# V2500 Propulsion System - Nacelle **SERVICE BULLETIN**

Subject: Transmittal of Revision 1 to Service Bulletin Number V2500-NAC-78-0166

NACELLE - EXHAUST – LOCKOUT FEATURE, AFT CASCADE SUPPORT RING, THRUST  
REVERSER, - INSPECTION/REWORK

# **V2500-NAC-78-0166**

Thrust Reverser Translating Sleeve Rigging Check Dimensions  
Figure 1

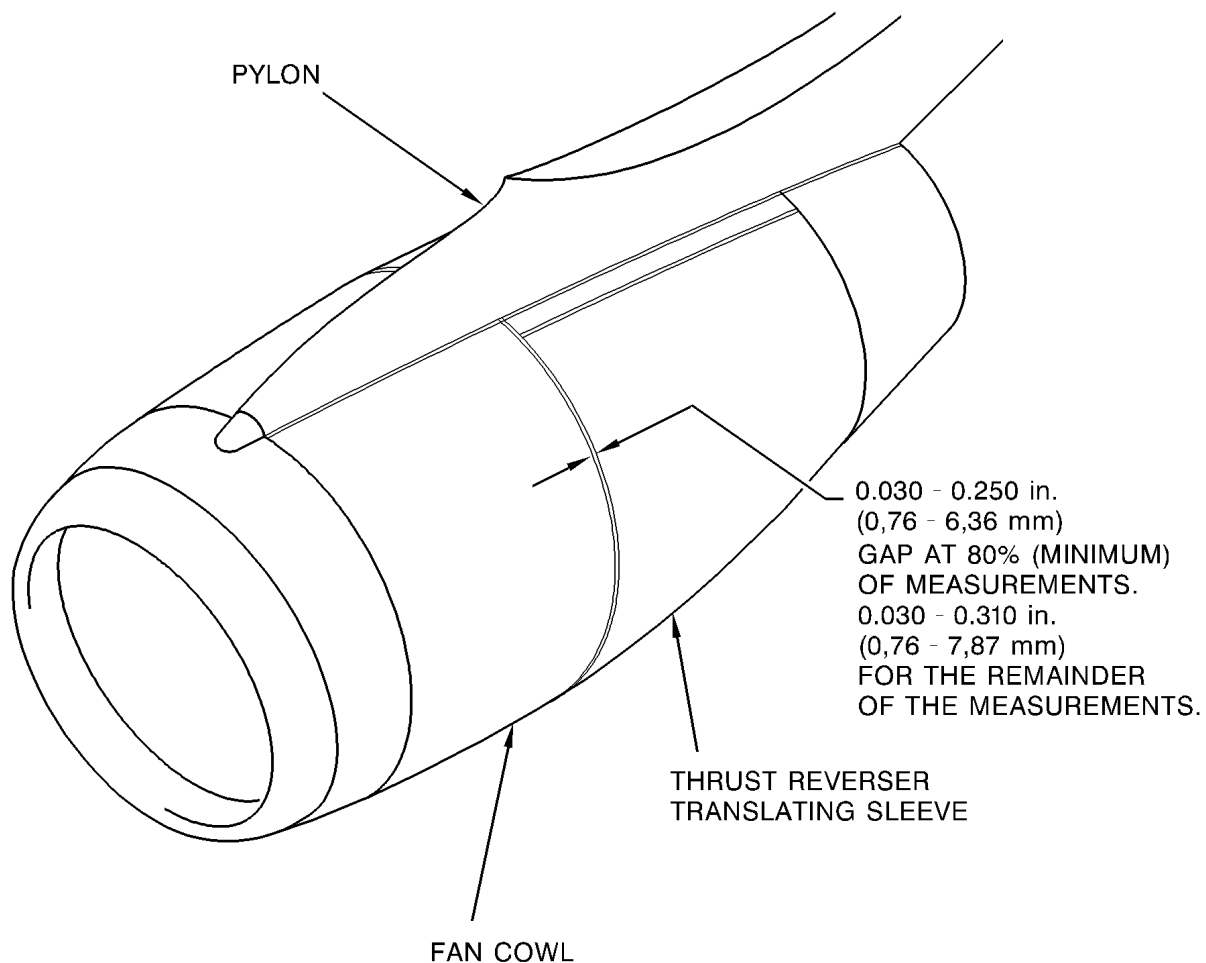
(1) To clarify instructions in Paragraph 3.A.(5) and Figure 1.

- (5) Check the dimension (gap) between the translating sleeve and the fan cowl as shown in Figure 1.
  - (a) Measure the gap between the translating sleeve and the fan cowl at 8 to 10 places equally spaced around the circumference.

Aft Cascade Support Ring Lockout Feature Lug Dimension Check and Pin Hole Enlargement  
Figure 2 (Sheet 1)

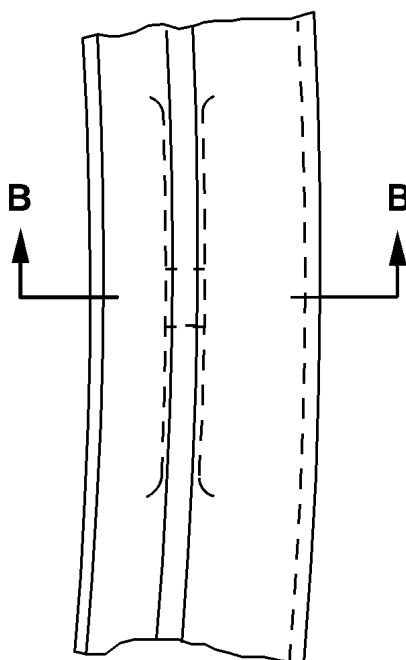
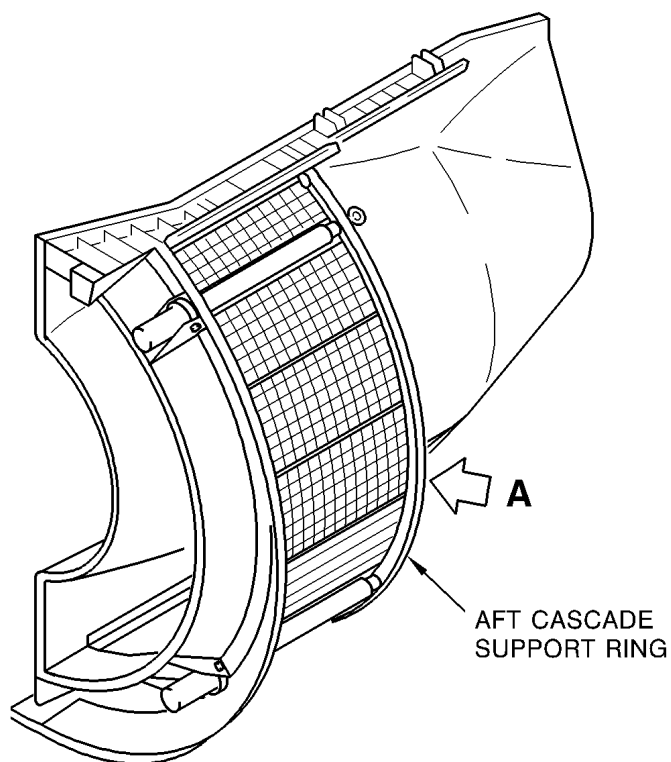
Because of engineering tolerance stack-up it is possible for the lockout pin feature in the aft cascade support ring to be located 0.25 inch too far forward. This results in misalignment with the lockout pin features in the translating sleeve outer panel and inner acoustic panel.

- (a) If the gaps are within the limits in Figure 2, go to step 3.B.(8).
  - (b) If the gaps are not within the limits in Figure 2, you must adjust the thrust reverser actuator and translating sleeve rigging. Refer to the Aircraft Maintenance Manual, Chapter 78-30-00, Page Block 501 then go to step 3.B.(6).

- (7) Attempt to install the thrust reverser lockout pin.
  - (a) If you can install the lockout pin, go to step 3.C.
  - (b) If you can not install the lockout pin go to step 3.B.(8).
- (8) Remove the translating sleeves. Refer to the Aircraft Maintenance Manual, Chapter 78-32-46 (78-32-76), Page Block 401.
- (9) Check the thickness of the aft cascade support ring lockout lug as shown in Figure 2.
  - (a) If the thickness is within the limits in Figure 2, go to step 3.B.(10).
  - (b) If the dimension is not within the limits in Figure 2, contact your IAE or BFGoodrich representative.
- (10) Make the hole in the aft cascade support ring lockout lug larger as shown in Figure 2.
